Subject: Response to Comments, Soil Gas Data Submittal, and Scope of Work for
Sub-Slab Soil Gas Sampling
City of Oakland Municipal Service Center (MSC)
7101 Edgewater Drive Oakland California

Reference: ACDEH Fuel Leak Case No. RO0000293; GeoTracker Global ID T0600100375

Subject: Response to Comments, Soil Gas Data Submittal, and Scope of Work for
Sub-Slab Soil Gas Sampling
RO0000293- City of Oakland Municipal Service Center
7101 Edgewater Drive, Oakland, California
GeoTracker Global ID T0600100375

CLIENT: Municipal Service Center	Revised Proposed MIP, UVOST and Groundwater Boring Locations
	PROJECT: Data Gap Analysis 7101 Edgewater Drive, Oakland CA	
PROJECT NUMBER: 0064.007.001	FIGURE 2

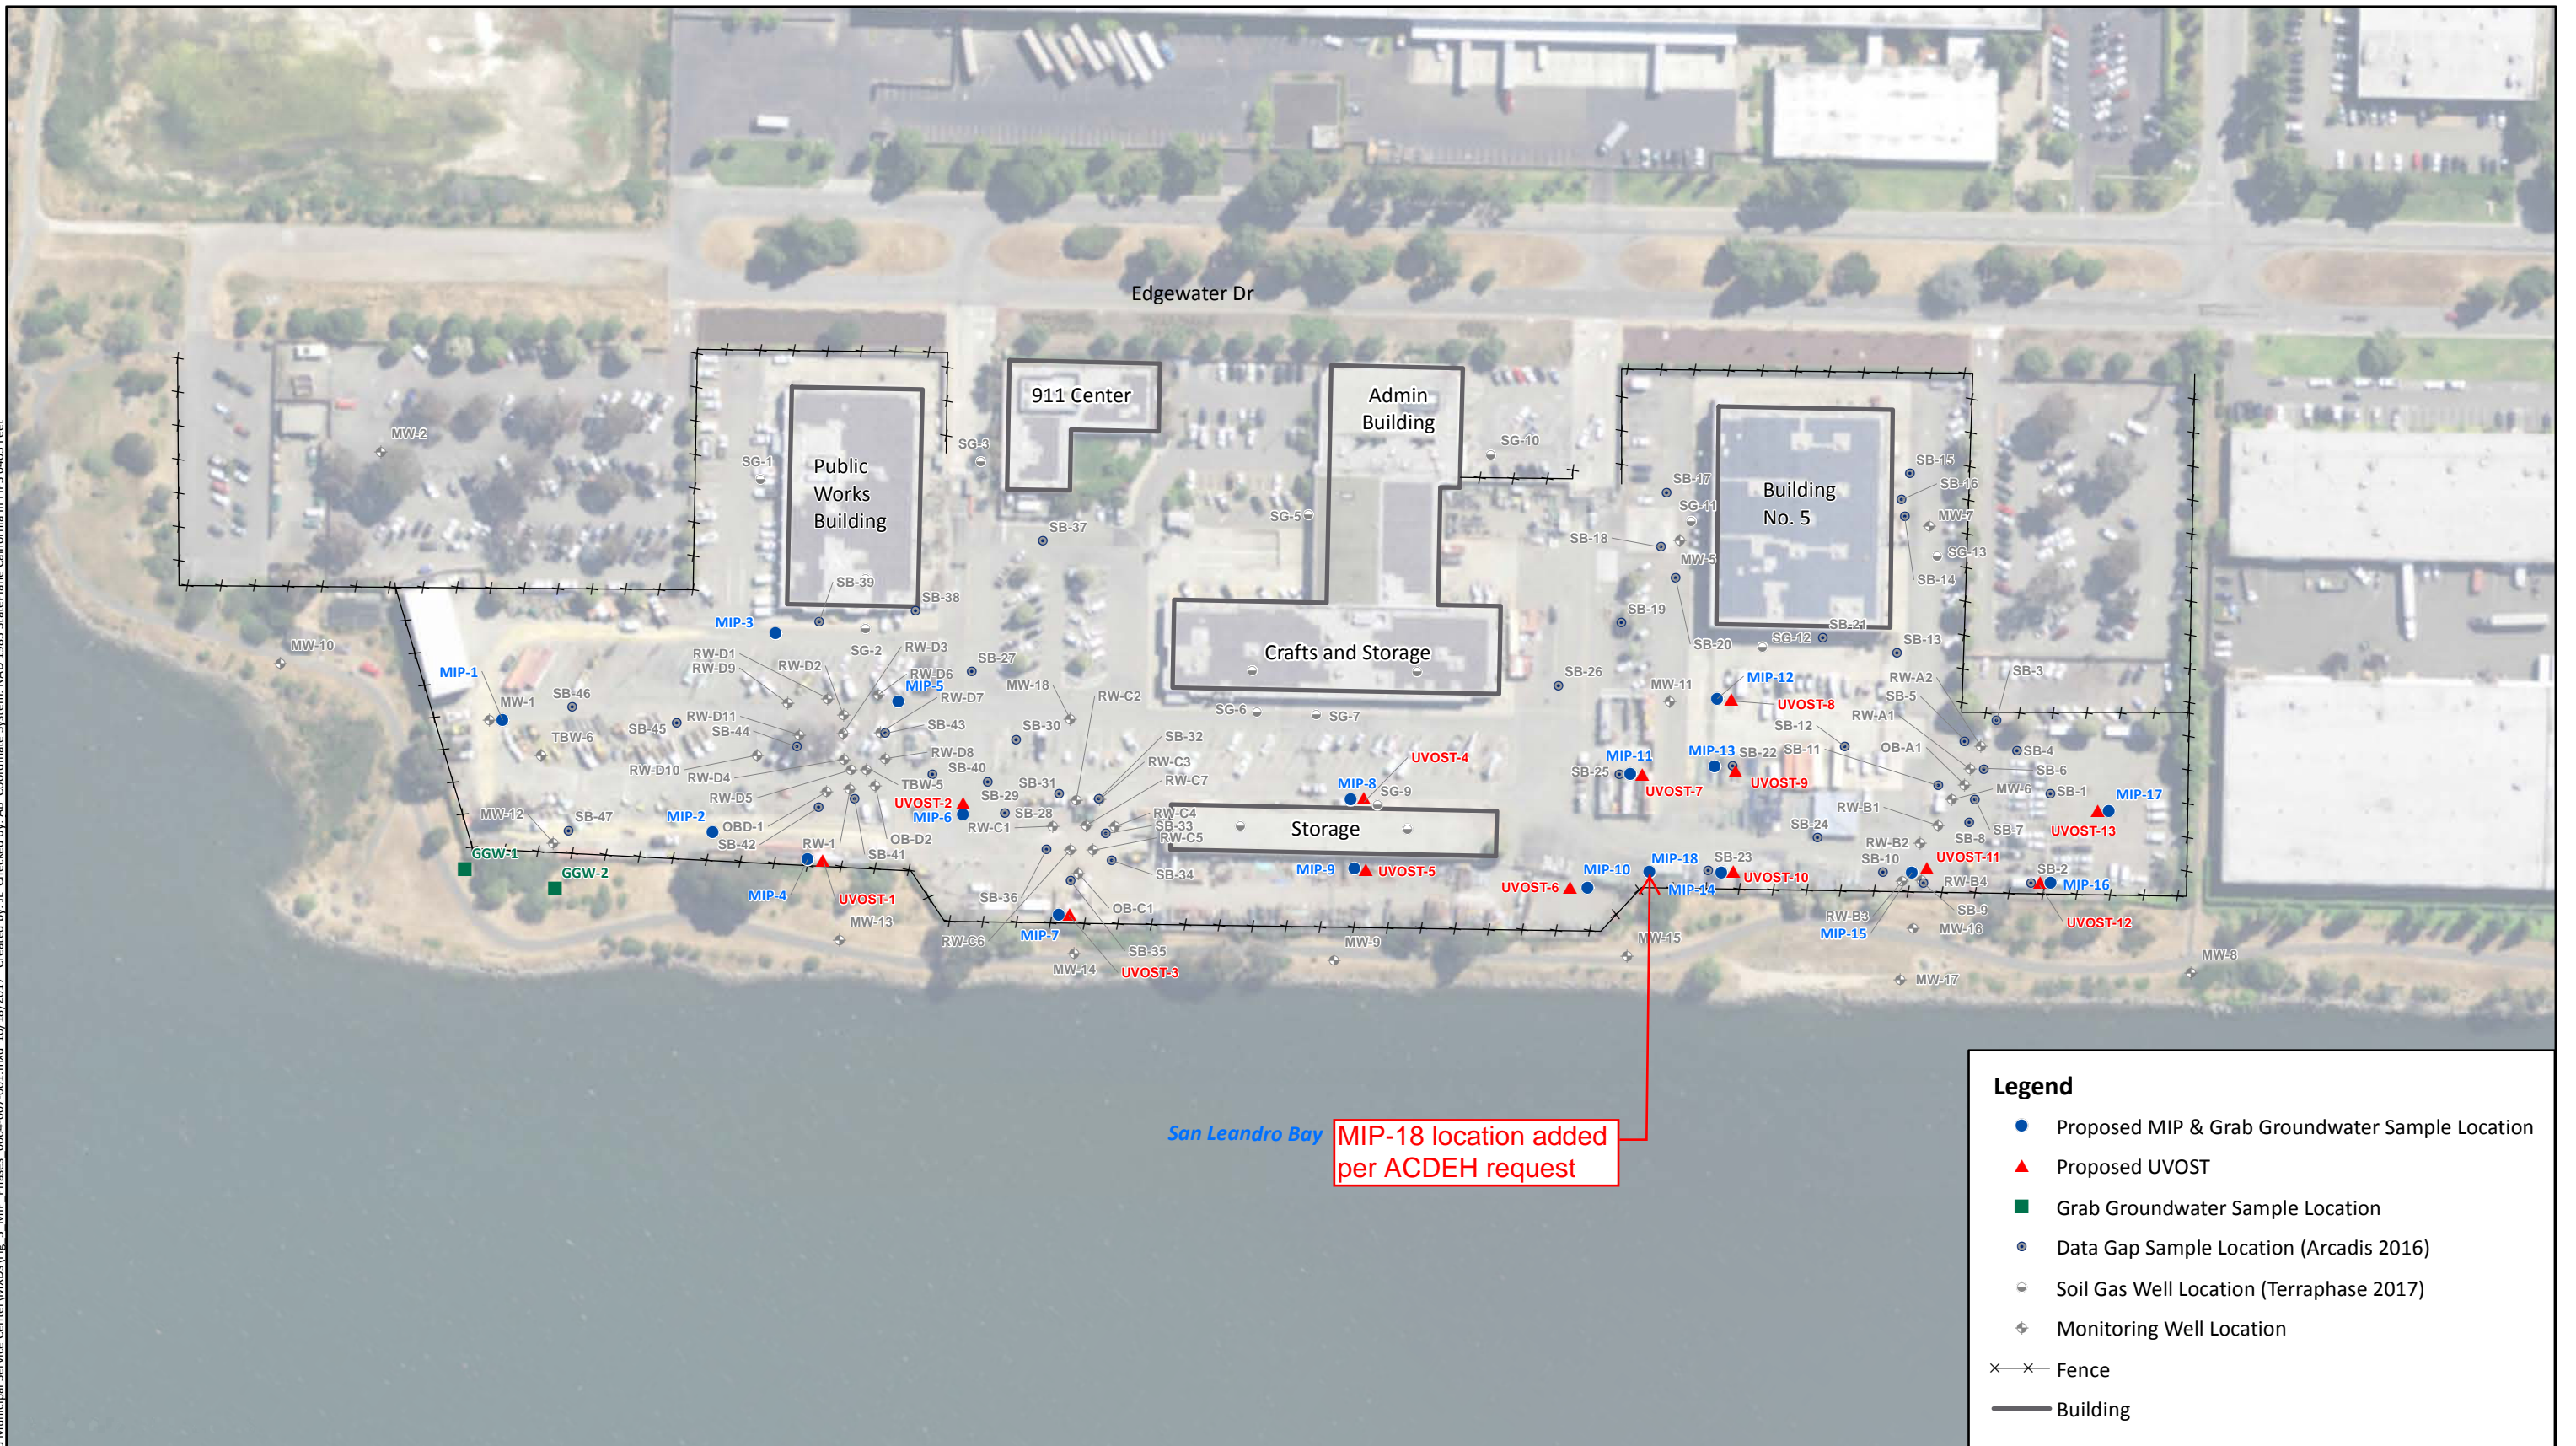
MIP Bore Locations - Based on ACDEH's review of the proposed MIP bore locations, we recommend an additional MIP bore. The location of the bore would be to provide data in the gap between the proposed locations of MIP-10 and MIP-14. Please add the additional bore, or alternatively, please provide ACDEH, by the date specified below, with the rationale why the bore is not needed.

Response to Technical Comment 2: This additional MIP location is acceptable. Terraphase provided email concurrence for this condition on October 18, 2017 as requested. The proposed location for this additional MIP bore is presented on Figure 2, attached.
